DATE: February 4, 2026
TIME: 9:00 A.M.
PLACE: Council Chambers

PLANNING COMMISSION AGENDA

Plan Review Comments

RE: Lighthouse Pointe – Amended PUD Preliminary Plan

**THE COTTAGES
AT LIGHTHOUSE POINT
PRELIMINARY PLAN**

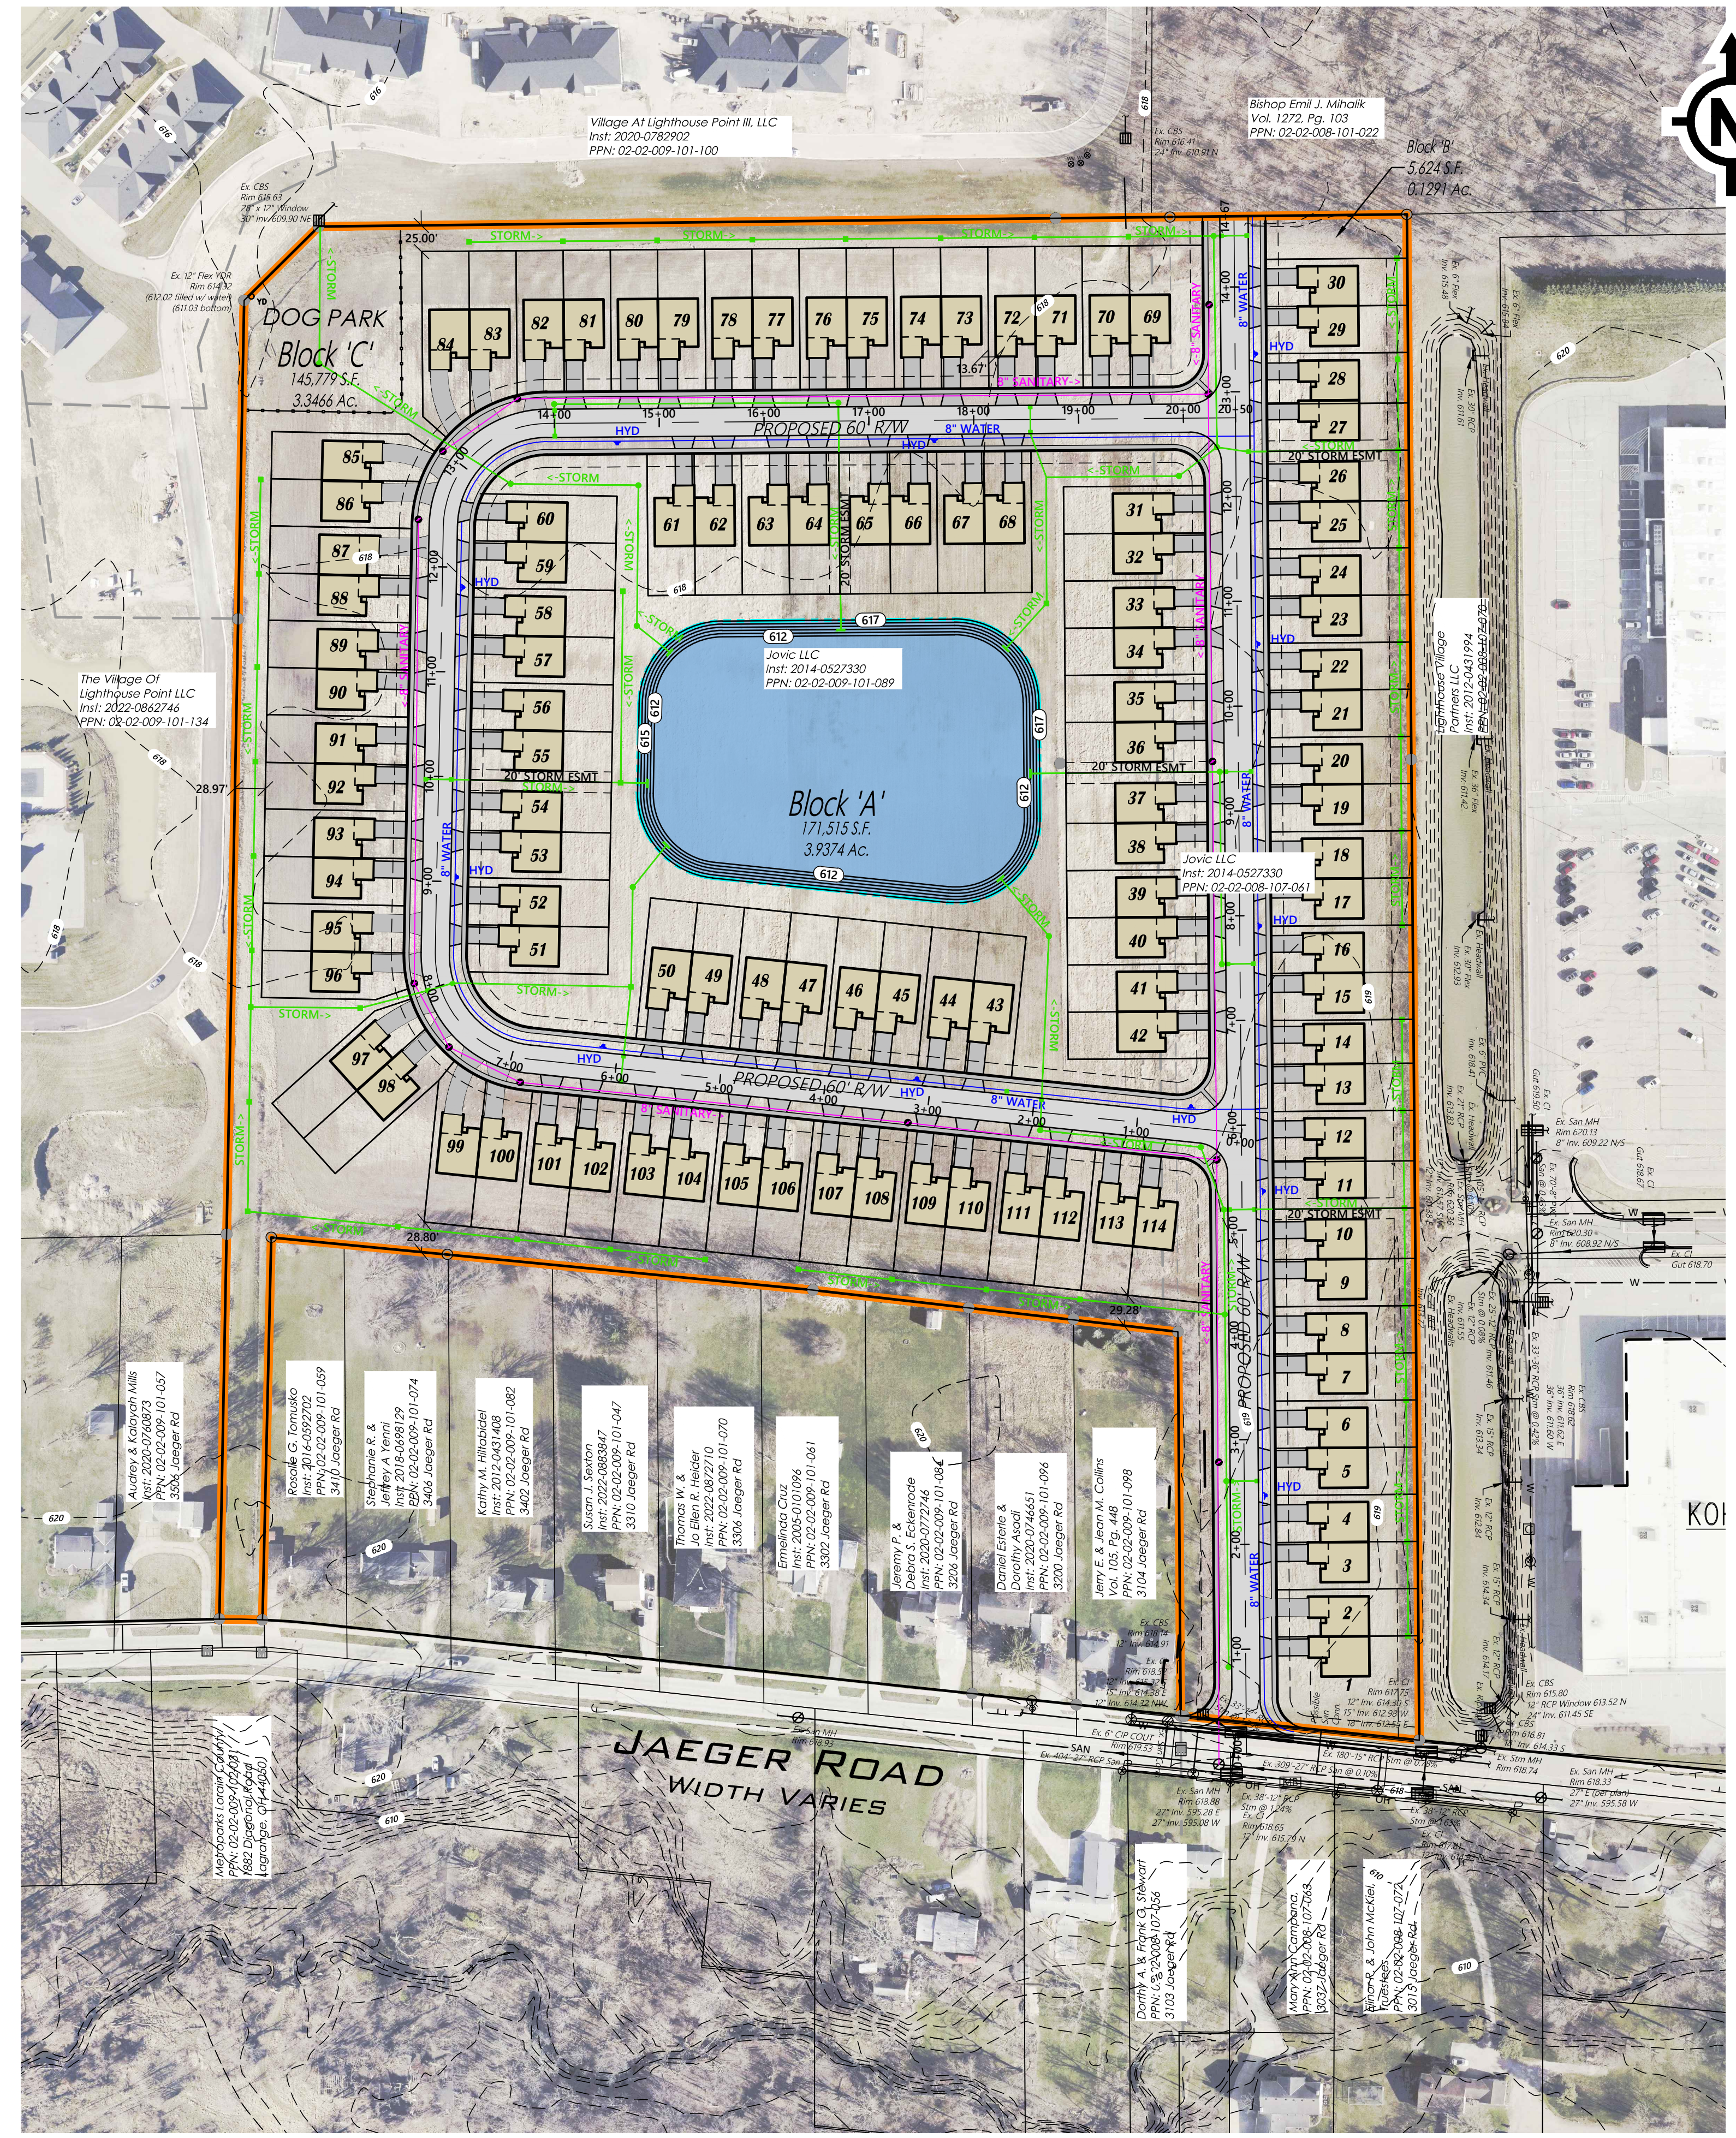
- We would prefer that the Sanitary Sewer NOT have two bulkheads in the NW portion of the development as this can create stagnant flow in the system and odors (parcels 85 & 86).
- Additionally, catch basins are not to be placed in driveway aprons.
- As far as watermain, it looks good as long as hydrants are not placed too close to driveways. There is a concern of a small dead-end on the NE section at plots 27-30 that could result in some pressure/quality concerns.
- We would have them add a water main interconnection that could follow the storm sewer through the dog park as there is an 8" PVC Main in that direction to loop to.

- There is a sanitary line and manhole that would be in the backyard of parcel 97/98. This may need to be represented on the plans, and it could possibly allow direction of the sewer in that direction if topography/grade allows to reduce a tap into the sewer line along Jaeger.
- Please include Pre- & Post-Drainage Calculations & Area of Disturbance as per [1529.08: Development Site One Acre in Size or Larger](#)
